Product Change Notification: P-20-018733

DYNAMIC D-5200M TAB HSG

Packing Method

D5200 TAB HSG

■ Packing Spec

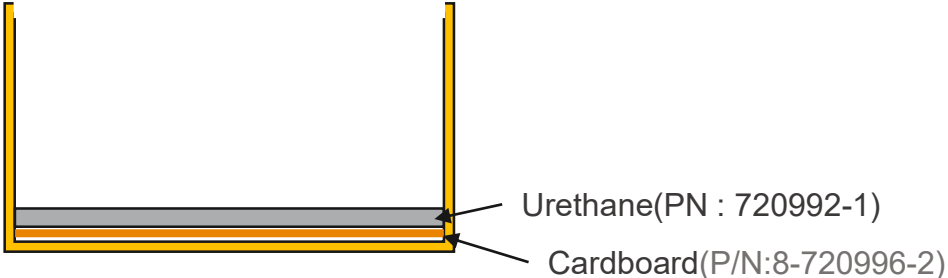
Packing Spec are changed to 107-78030 from FJPI-*-917808-2,3 and FJPI-*-917809-2,3.

BEFORE : Two Poly Bags with each 30 or 40pcs packed to the Box.

AFETER : Place the product in line to the Box.

Packing Quantity[pcs]							
	*-917808-2		*-917808-3		*-917809-2		*-917809-3	
	BEFORE	AFTER	BEFORE	AFTER	BEFORE	AFTER	BEFORE	AFTER
Poly Bag	40	-	30	-	40	-	30	-
Box	80	90	60	70	80	70	60	48
Shipper Box	320	360	240	280	320	280	240	192

Packing Method

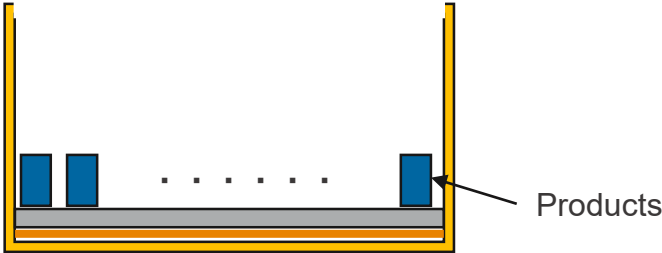
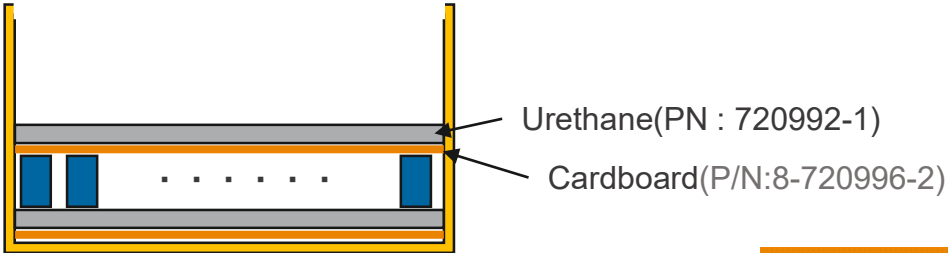
1. Lay the Cardboard(P/N:8-720996-2) and Urethane(P/N:720992-1) to the Box(P/N:912013-2).

2. Place the products in line as the picture shows.

Packing Method

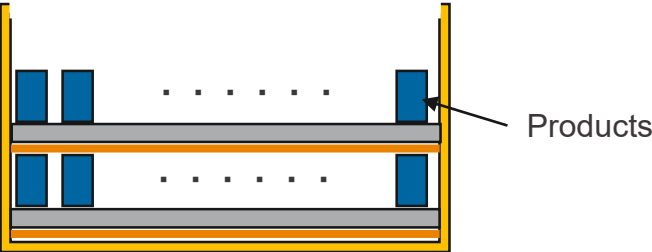
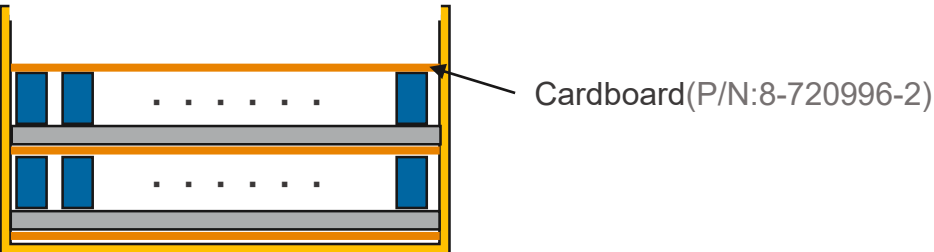
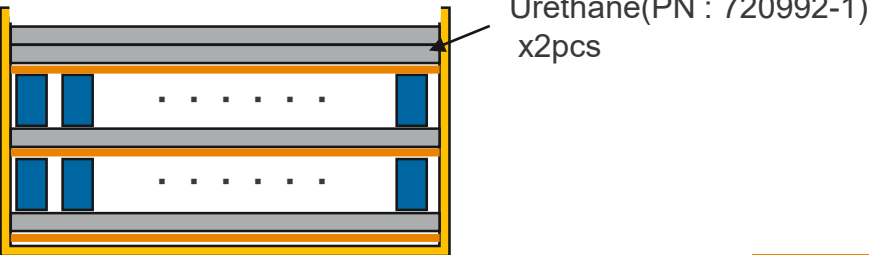
4. Place the products in line as the picture shows.

5. Lay the Cardboard(P/N:8-720996-2) onto the products.

6. Lay the two Urethane(P/N:720992-1) onto Cardboard(P/N:8-720996-2).

*-917808-2 D5200 TAB HSG 4P F/H

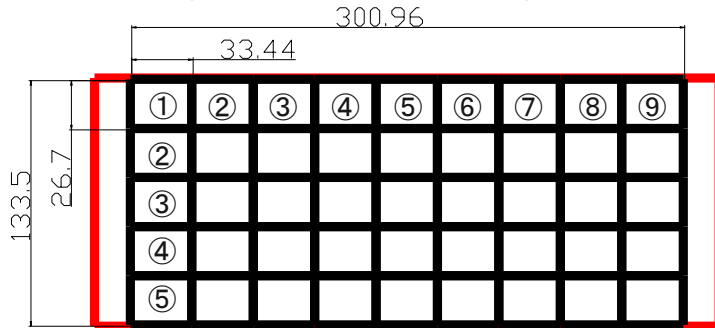
Product size : 26.7mm x 33.4mm

Quantity : 9pcs x 5line x 2layer = 90pcs

*-917808-3 D5200 TAB HSG 6P F/H

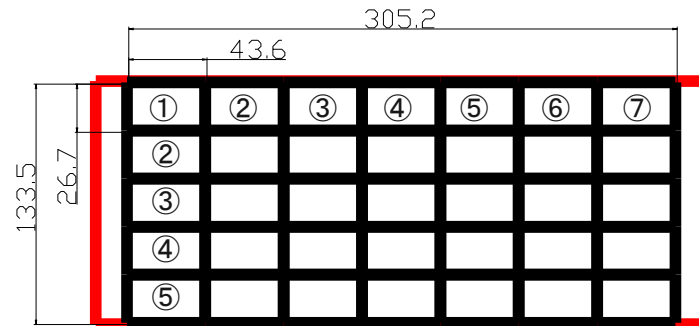
Product size : 26.7mm x 43.6mm

Quantity : 7pcs x 5line x 2layer = 70pcs

*-917809-2 D5200 TAB HSG 4P P/M

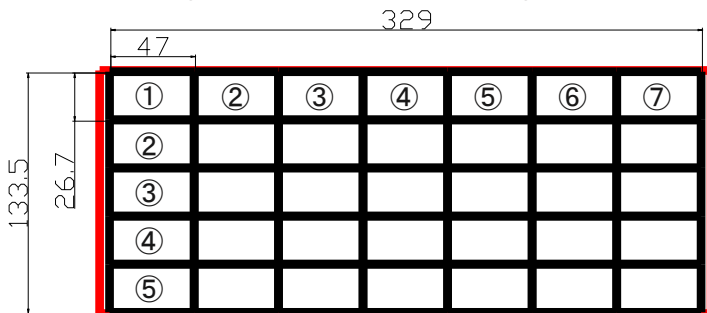
Product size : 26.7mm x 47mm

Quantity : 7pcs x 5line x 2layer = 70pcs

*-917809-3 D5200 TAB HSG 6P P/M

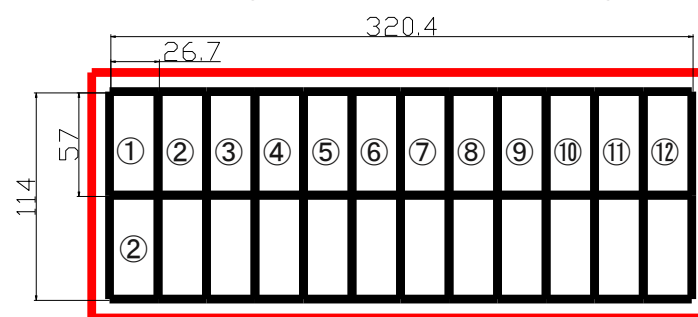
Product size : 26.7mm x 57mm

Quantity : 12pcs x 2line x 2layer = 48pcs
